Bid Addendum No. 1
March 24, 2025

*Subject: Village of Antioch
Woods of Antioch Pavement Reconstruction
Section No.: 24-00048-00-PV
March 27, 2025 Letting*

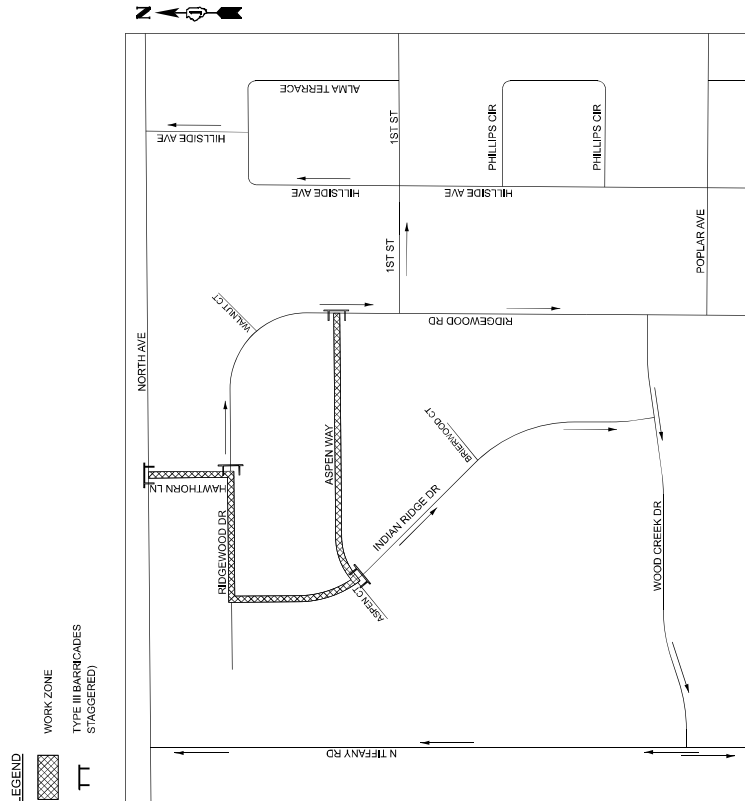
Modifications to the Suggested Sequence of Construction plan:

The Suggested Sequence of Construction plan notes have been updated to provide the contractor additional time to complete the stage construction.

Replace the Suggested Sequence of Construction plan provided in the original bid package with the enclosed Suggested Sequence of Construction plan.

THE CONTRACTOR SHALL BE REQUIRED TO COMPLETE PAVEMENT REMOVAL, EXCAVATION, AND AGGREGATE BASE COURSE INSTALLATION ON EACH RESPECTIVE STAGE TO HAVE THE STREET REOPENED TO TRAFFIC WITHIN 7 DAYS OF COMPLETION OF EACH STAGE. FAILURE TO DO SO SHALL RESULT IN A FINE OF \$2,000 PER EACH CALENDAR DAY OF OVERFLOW.

THE CONTRACTOR WILL BE REQUIRED TO COMMENCE CONSTRUCTION OF HMA BINDER COURSE WITHIN 7 CALENDAR DAYS UPON COMPLETION OF THE AGGREGATE BASE COURSE IN EACH STAGE. FAILURE TO DO SO SHALL RESULT IN A CHARGE OF \$1,000 PER EACH CALENDAR DAY OF OVERRUN.
